Access Compliance Report

Public Rights-of-Way

(Curb Ramps)

Intersection ID: N/A	Main Street: PROVIDENCE_RD	Cross Street: RAINTREE_LN	Location: SW
ADA ID: 449B30259F2B	Ramp Type: PerpDiag	Initial Pass/Fail: Fail	Overall Compliance: No
Codes/Mitigation Info/Possible Solution		Field Measurements/Component Compliance	
Severity Score: 18.75

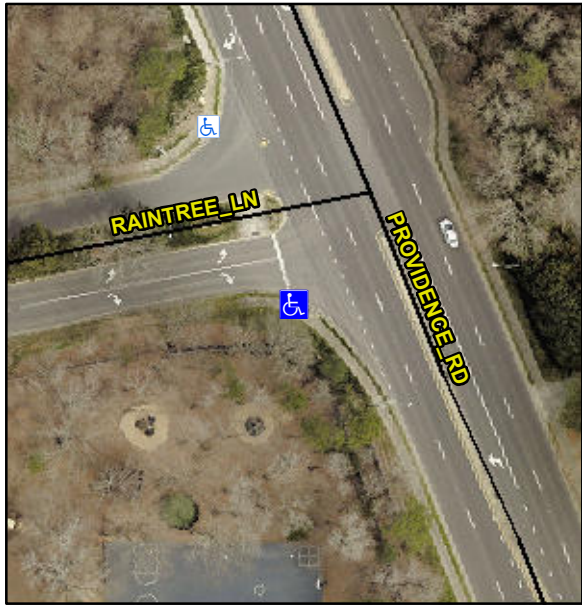
R304.5.1, R304.5.3

Compliance	Description	Data	Compliance	Description	Data
N/A	Ramp Length (in)	77.0	Yes	Ramp Slope (%)	7.6
No	Ramp Width (in)	32.0	No	Ramp XSlope (%)	3.9
N/A	Flare Type LT	N/A	N/A	Flare Type RT	N/A
N/A	Flare Slope LT (%)	N/A	N/A	Flare Slope RT (%)	N/A
N/A	Flare Traversable LT?	N/A	N/A	Flare Traversable RT?	N/A
N/A	Landing Length (in)	N/A	N/A	DWS Provided?	N/A
N/A	Landing Width (in)	N/A	N/A	DWS Contrast?	N/A
N/A	Landing Slope (%)	N/A	N/A	DWS Length (in)	N/A
N/A	Landing X Slope (%)	N/A	N/A	DWS Full Width?	N/A
N/A	Landing Curb? (Y/N)	N/A	N/A	DWS Offset (in)	N/A
N/A	Shared Landing?	N/A			
N/A	Gutter Ponding?	N/A	N/A	Gutter Slope (%)	N/A
N/A	Gutter Lip Ht (in)	N/A	N/A	Gutter X Slope (%)	N/A
N/A	Painted X Walk1?	No	N/A	Painted X Walk2?	No
	X Walk 1 Direction	To E		X Walk 2 Direction	To NW
N/A	X Walk 1 Width (in)	N/A	N/A	X Walk 2 Width (in)	N/A
	X Walk 1 Slope (%)	2.6		X Walk 2 Slope (%)	1.5
	X Walk 1 X Slope (%)	2.1		X Walk 2 X Slope (%)	4.4

Remove & Replace Curb Ramp With Two New Directional Ramps or Equivalent.
